ISSUE DATE:
May 30, 2023

Re: Center Stage Planned Development
Keller, Texas

CHANGES FROM JANUARY 29, 2020 DRAFT

CHANGES FROM MARCH 12, 2020 DRAFT

FIGURE 3.1
CONCEPT PLAN

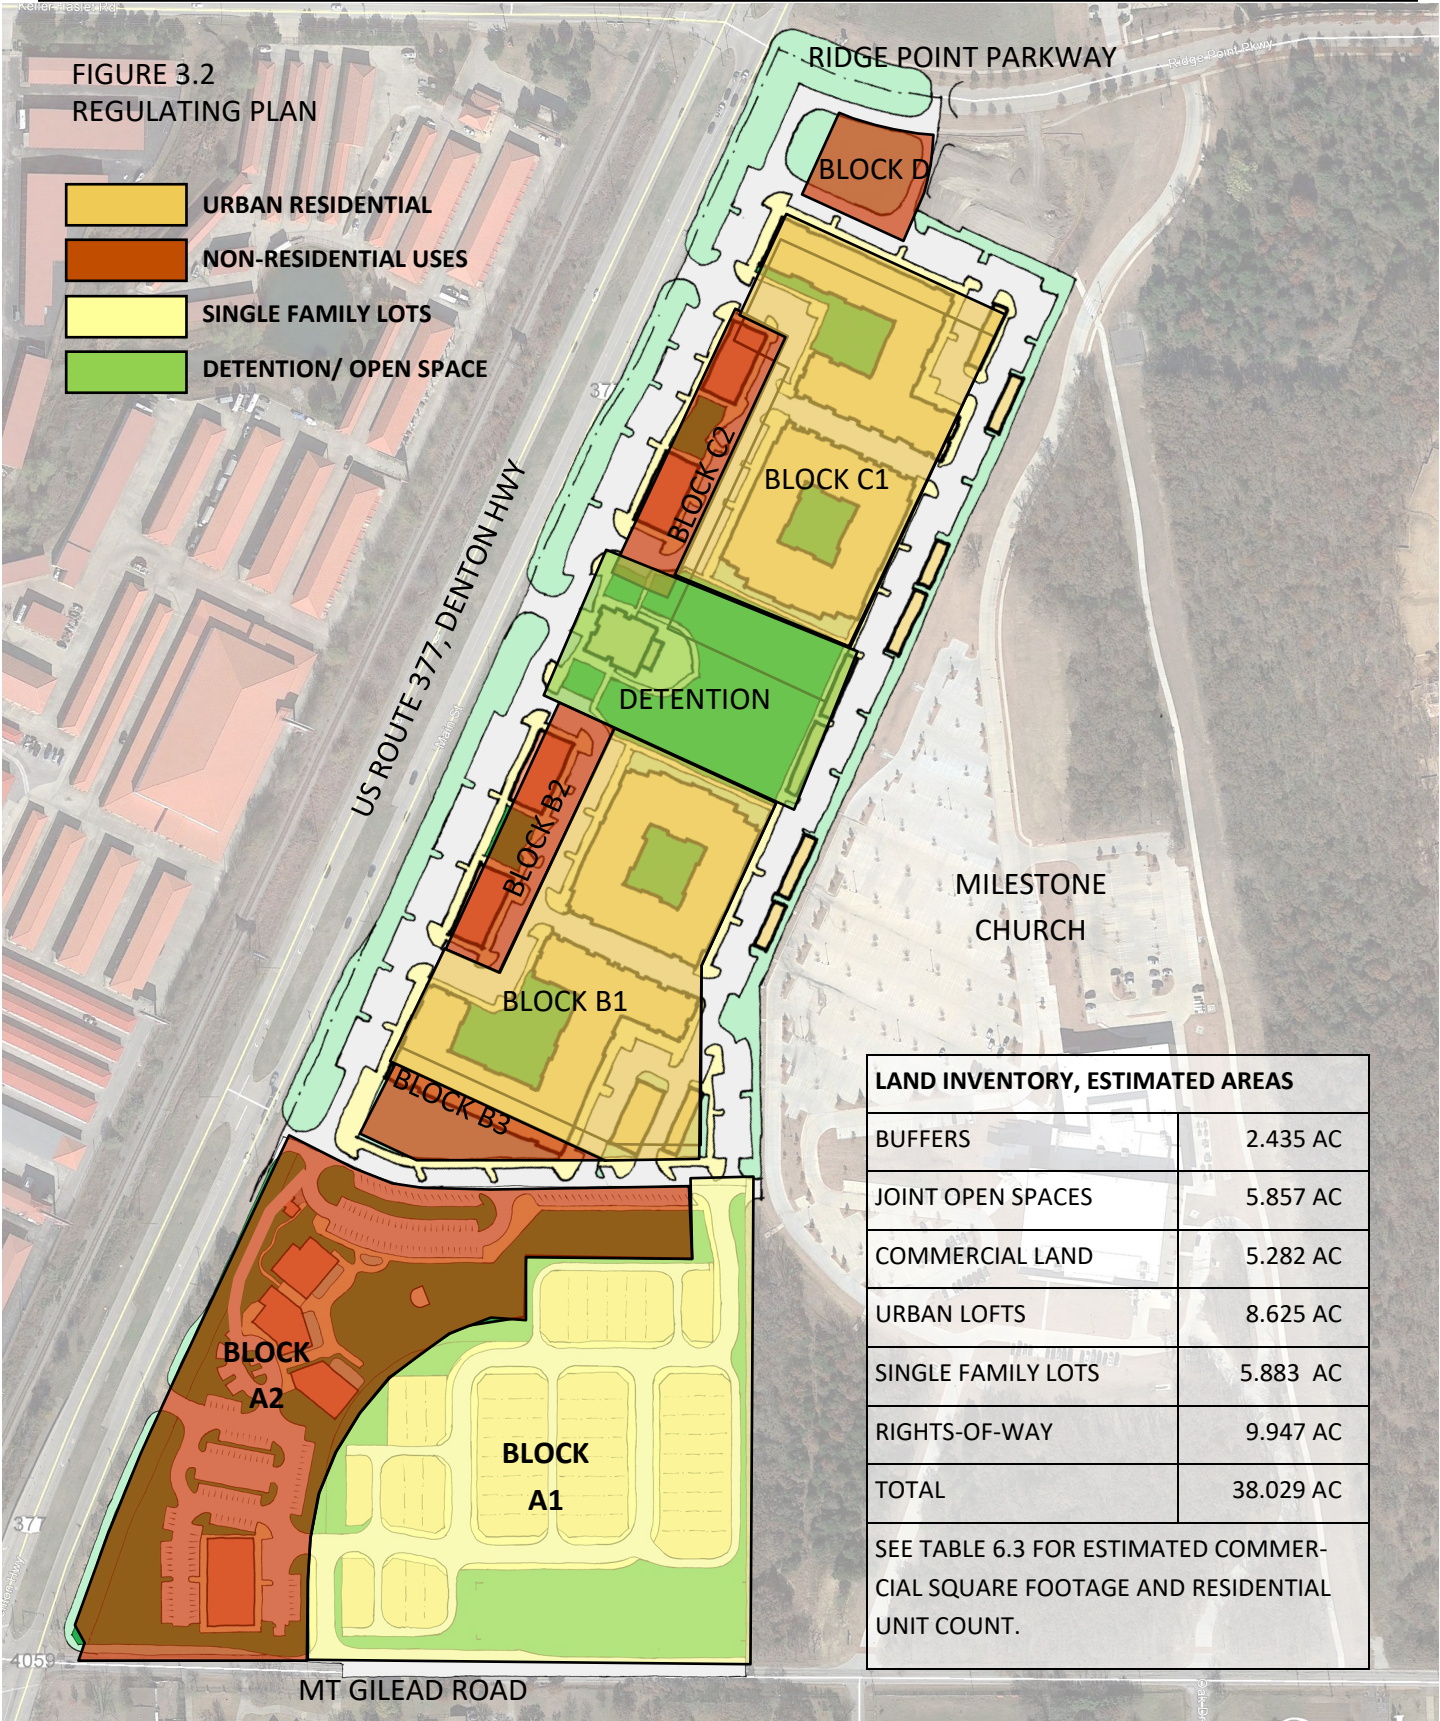
(P11): updated figure 3.1 concept plan

**FIGURE 4.1
STREET PLAN**

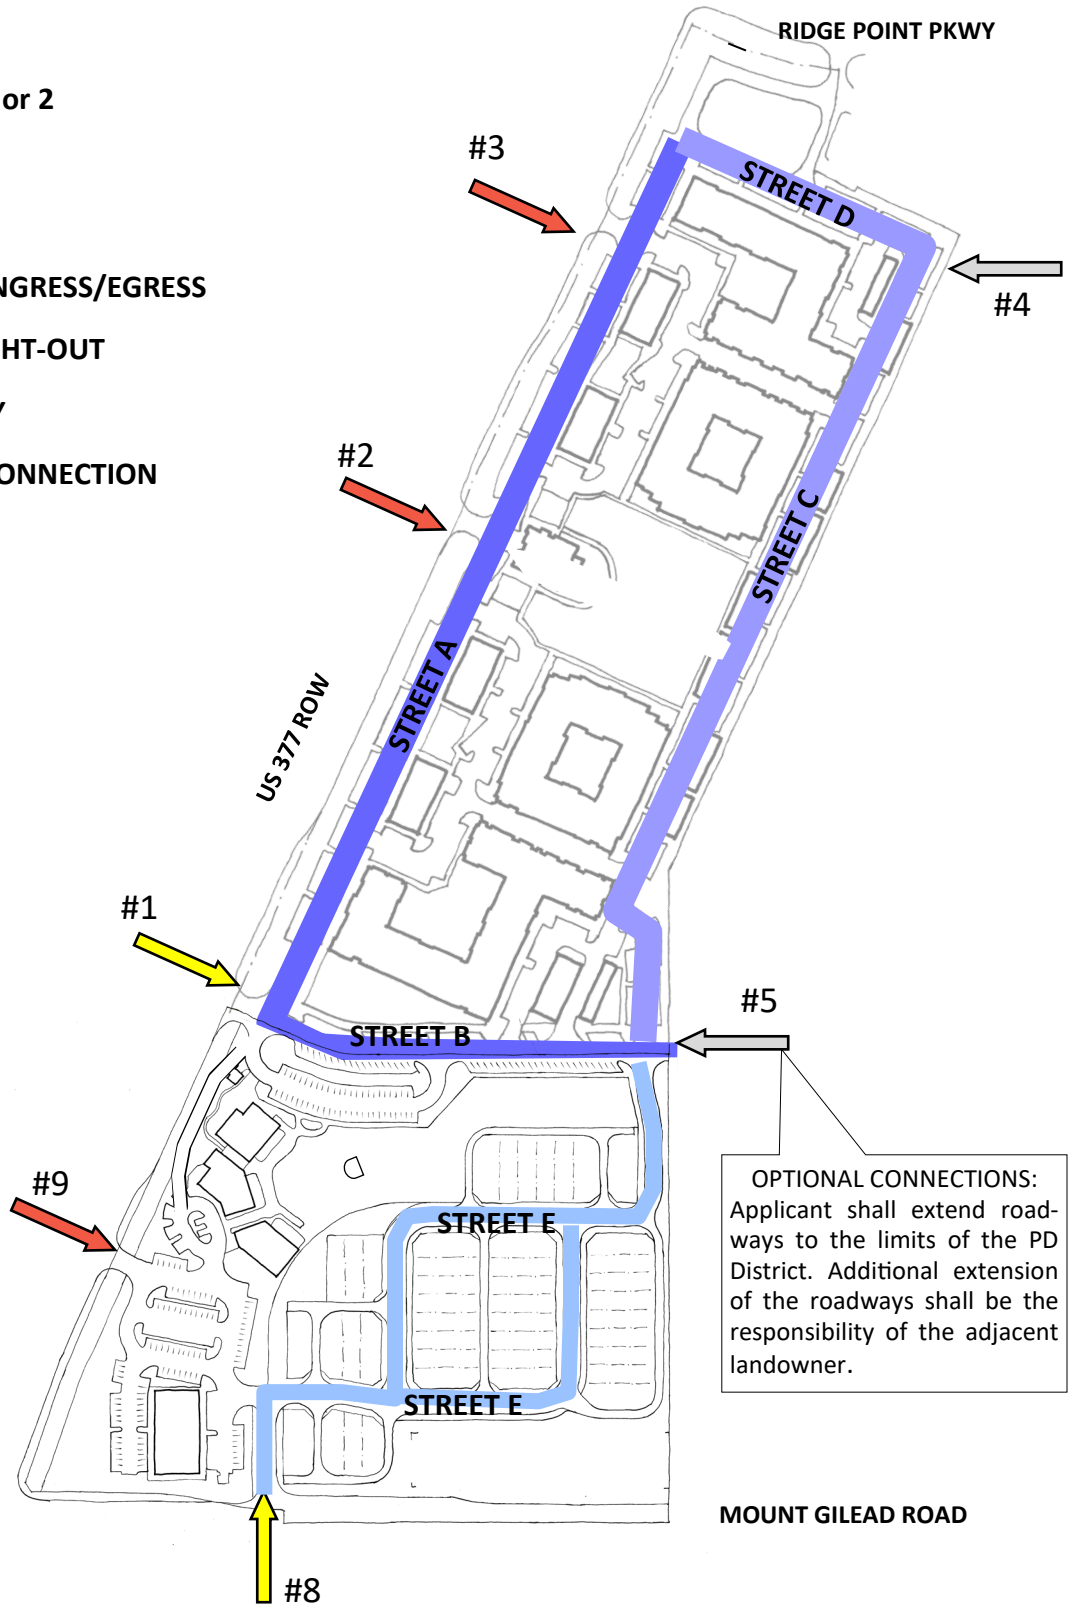
- P13: Table 3.1 Add Note 3,
- P14 Table 3.3: Revise Table for Engler Settlement
- P16: Figure 4.1: Revise Street diagram, Revise Street Types; add Note 2

(P16): Updated Note 4 to remove reference to Streets F&G, updated Figure 4.1

**FIGURE 4.2
STREET SECTIONS**

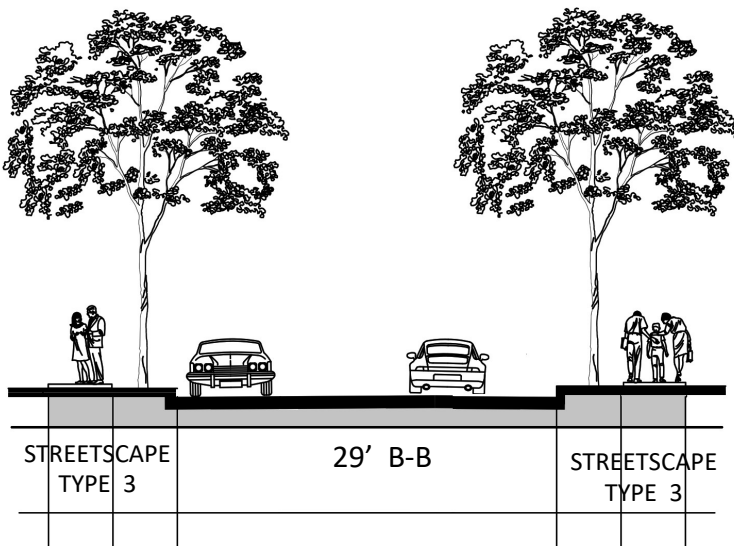
- Deleted Page P18:** page deleted, pedestrian network added to Section 5
- P19: (P18) Revise street sections, combine types 1 & 2, rename type 3 to type 2,

PEDESTRIAN STREETScape 1

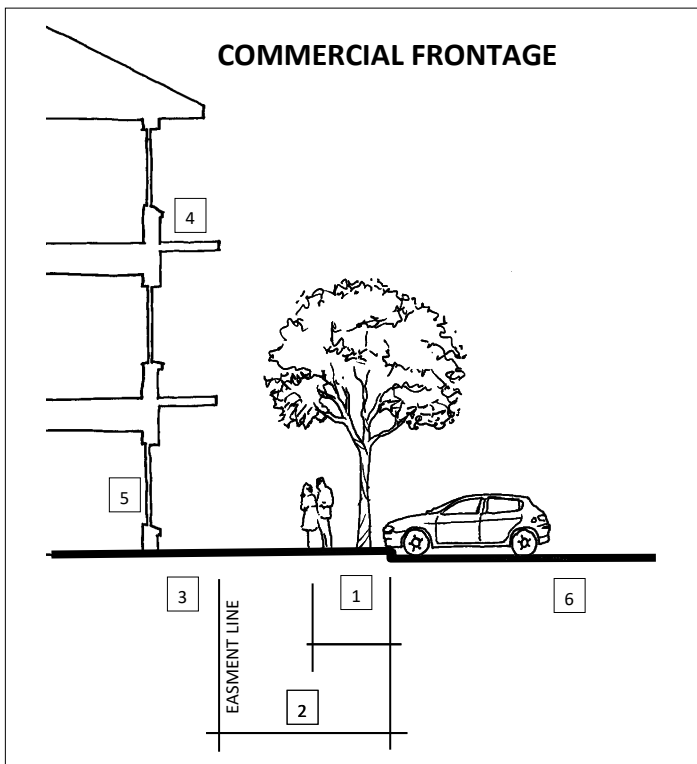
- Deleted Page P20**
- P21 (P19): Streetscape 1: add tree setback, add 10’ minimum clearance.
- P22 (P20): Delete Streetscape Type 3, Re-label Streetscape 4 as streetscape 3.

FIGURE 5.1
OPEN SPACE PLAN

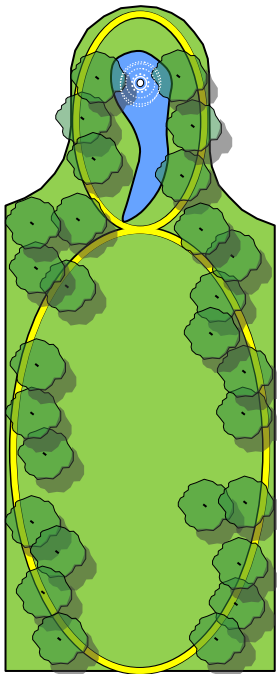
- P22 (P20): Item 2, correct text, Item 6: correct text.
- P24 (P22): Figure 5.1: Graphically indicated required buffers. Open space areas indicated graphically are larger than minimum areas indicated in tabulation. Added Buffers to bottom of table 5.1.

(P22): updated figure 5.1 and table 5.1 to remove Linear Park OS 8 and incorporate its 0.2 acre minimum into OS 1, illustrate OS 3's current configuration (its as-built condition exceeds the minimum 1.4 acre open space) and show the required buffer yard along 377 (30') and Mt Gilead (15')

**FIGURE 5.3
PEDESTRIAN NETWORK**

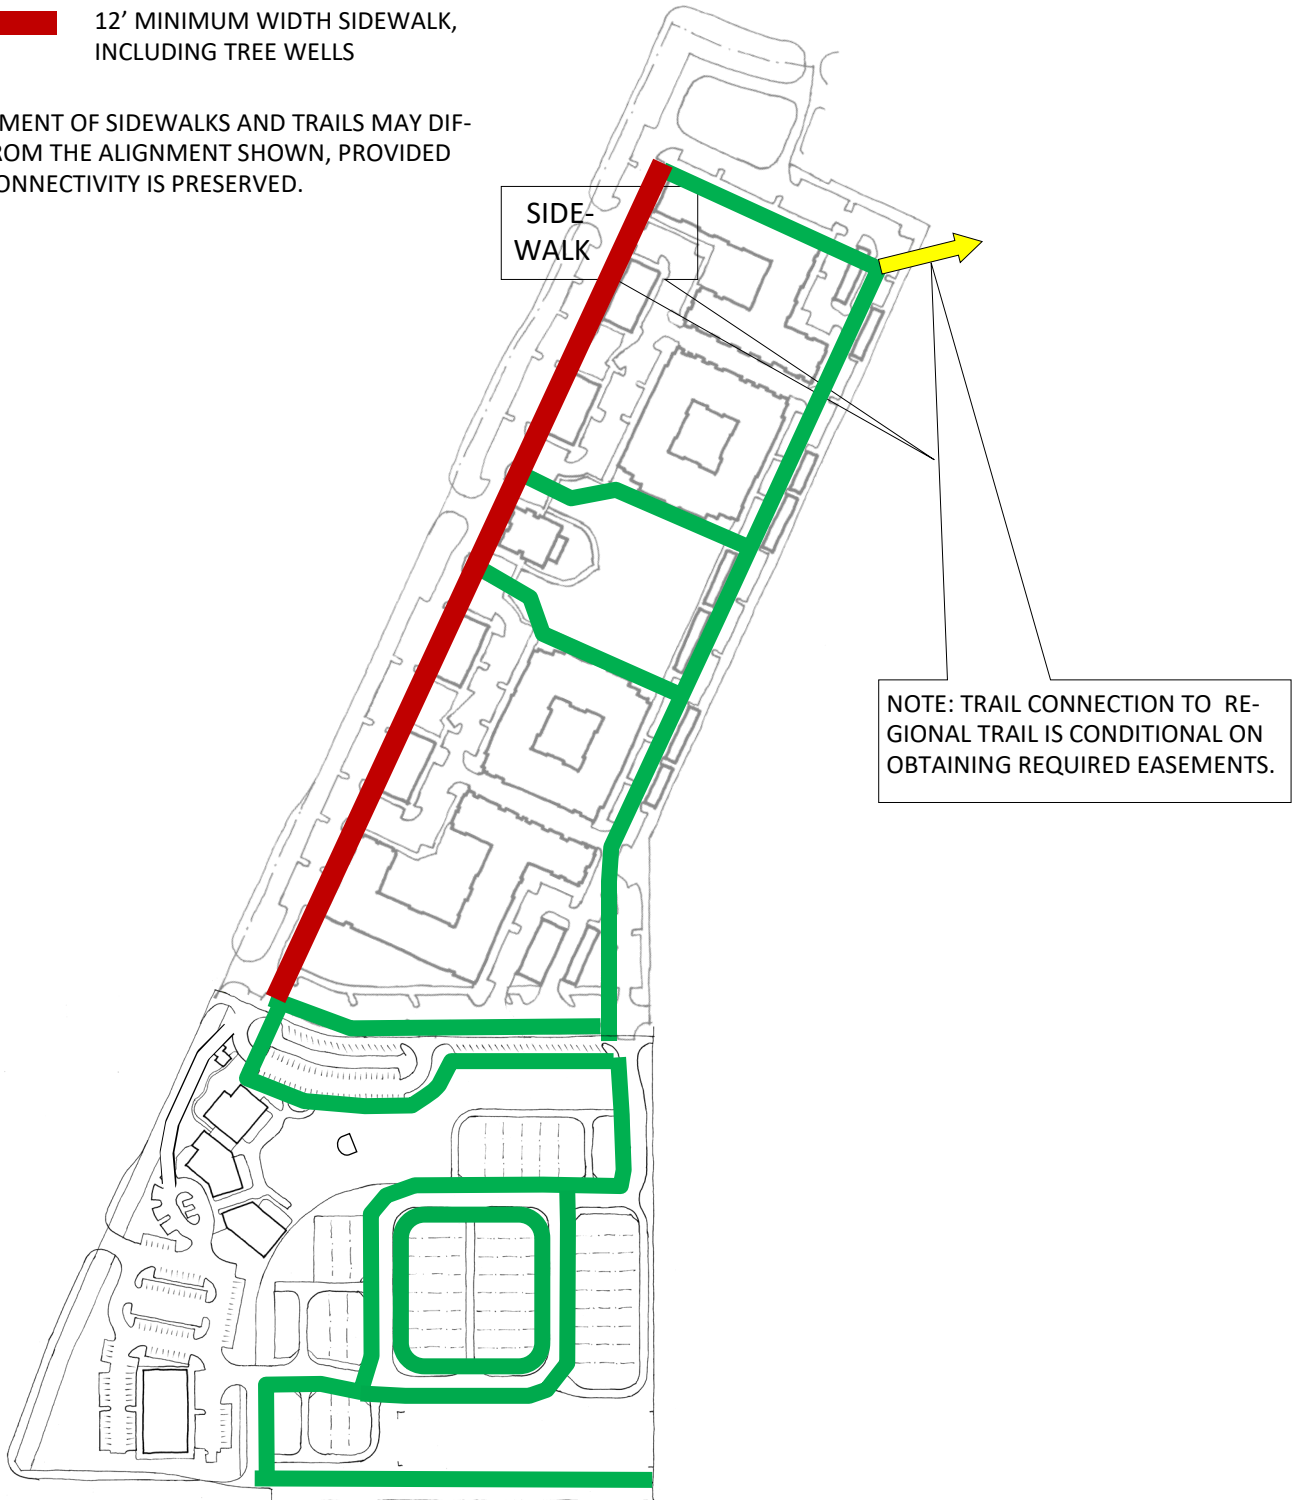
- Added Page P25:** Add Figure 5.3, revised pedestrian network figure.
- P28 (P27).B: paragraph deleted, Old paragraph F /now Paragraph G: Added ‘Readily visible’ text

(P25): updated figure 5.3

Figure 6.1: Head-in and Angled-in Parking Dimensions

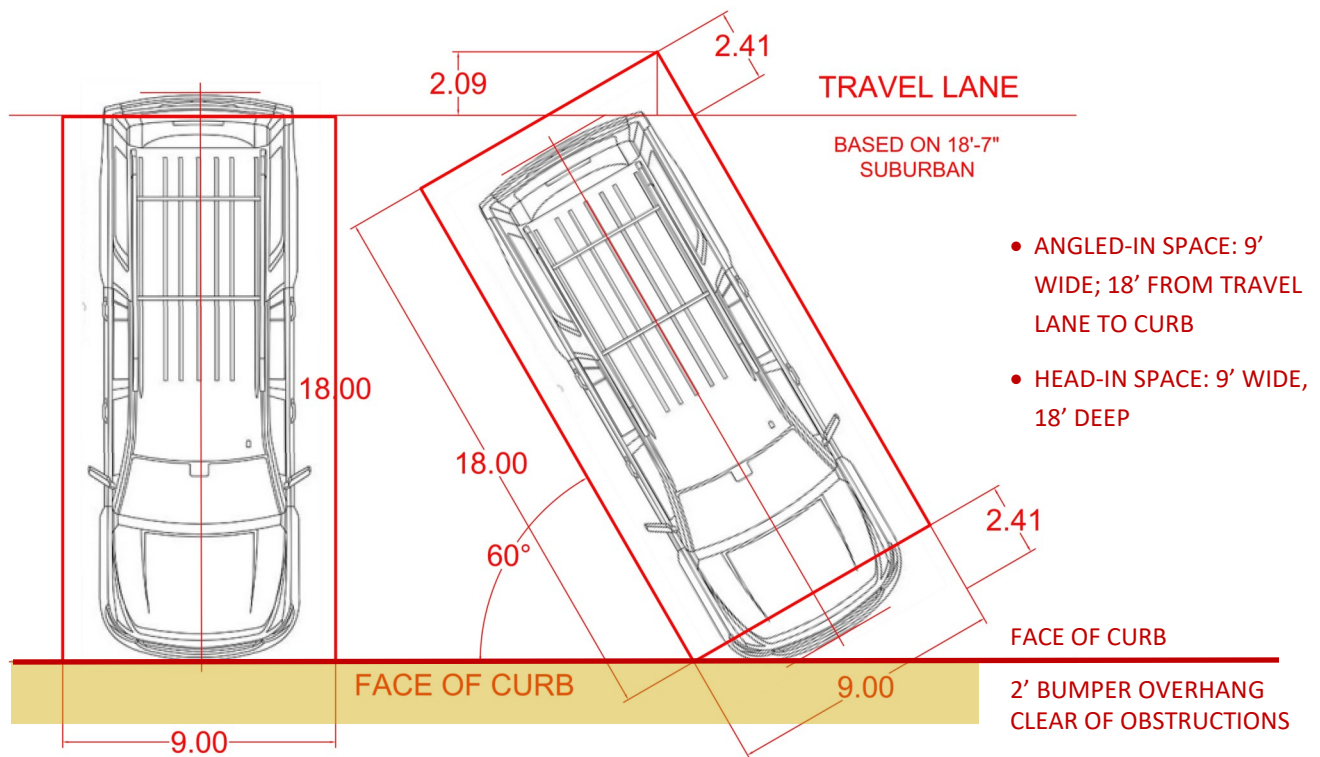
- P29 (P28) Table 6.3: reformatted table to add required parking for each block.
- P29 (P28) Figure 6.1: substituted new graphic for parking space diagram

**FIGURE 7.2
GROUND FLOOR DESIGN TYPES FOR
BLOCKS B AND C**

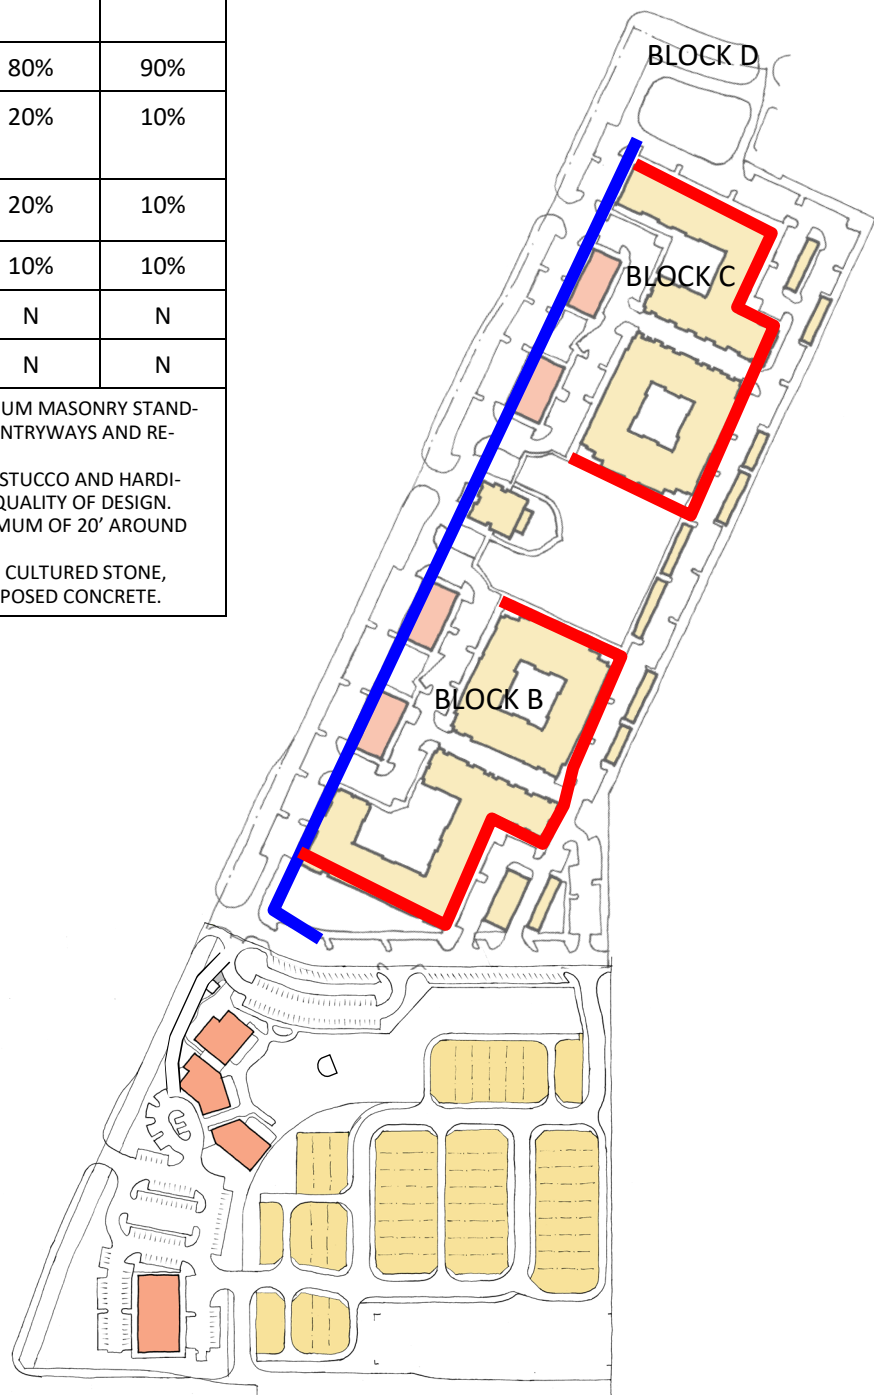
- P31 (P30). 7.B: Delete “and to allow...public.”
- P31(P30), Delete paragraph D
- P31(P30). 7.I.1: Delete “fronting on...streets”
- P33 (P32). Figure 7.1: Spelled out “ground Floor Type. Eliminated Type 2 at northeast corner of Block C

(P32): updated figure 7.2
